Quality Assurance (Management Measures) RAIs

QA-1 (QA-2) *In the fourth paragraph of the introduction of Section 11, “Management Measures” the application states, “The provisions contained in this QA Program Description are applicable during design and construction of the IIFP Facility for design activities taking place beginning on the date the DB contactor assumes the detailed design and engineering role and establishes the design organization and controls during design and construction phase of the IIFP Facility beginning on the date the DB contactor assumes the detailed design and engineering role and establishes the design organization and controls.” Consistent with 10 CFR 70.64, “Safety program and integrated safety analysis” clarify this sentence and its intent, and correct the editorial errors. In addition, clarify if the provisions in Chapter 11 or QAPD are just applicable to design and construction? What documents will be applicable to operations?*

Figure 11-2 Plant Operation Organization

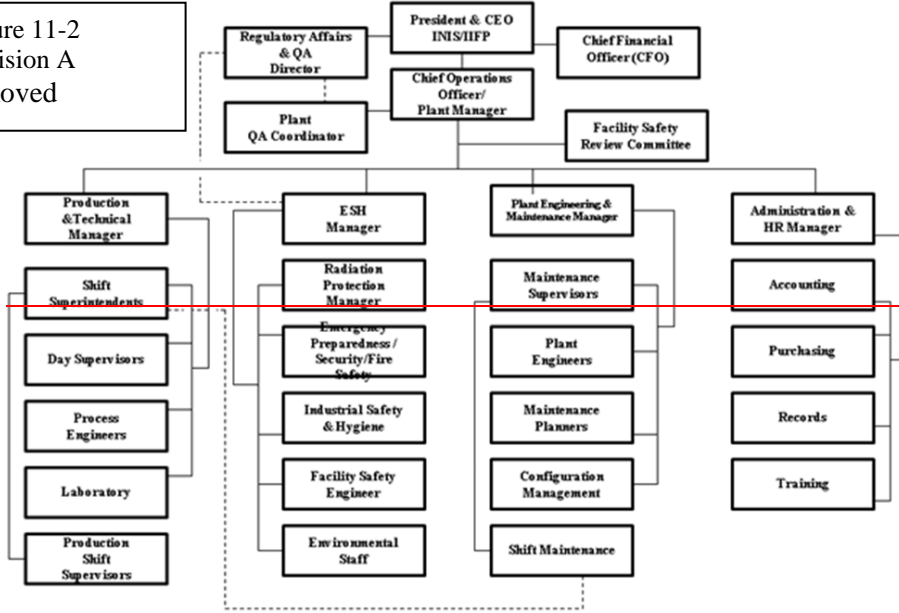
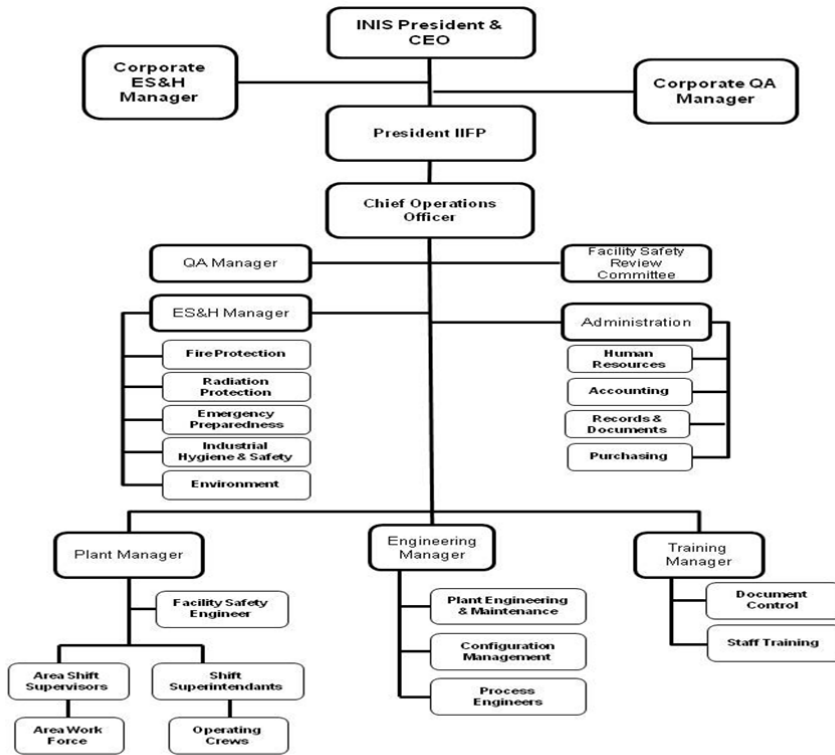
Figure 11-2 “IIFP Plant Organization during Operations of the FEP/DUP Facility” will be removed and replaced with Figure 11-2 “Plant Operation Organization” depicting the organizational structure of the Facility, in response to RAI OA-7A.

License Documentation Impact: Remove Figure 11-2 and title and replace with revised Figure 11-2 "Plant Operations Organization" in the Chapter 11 of IIFP License Application, Revision A, (also in response to RAI OA-7) the revised Figure and will appear as follows:
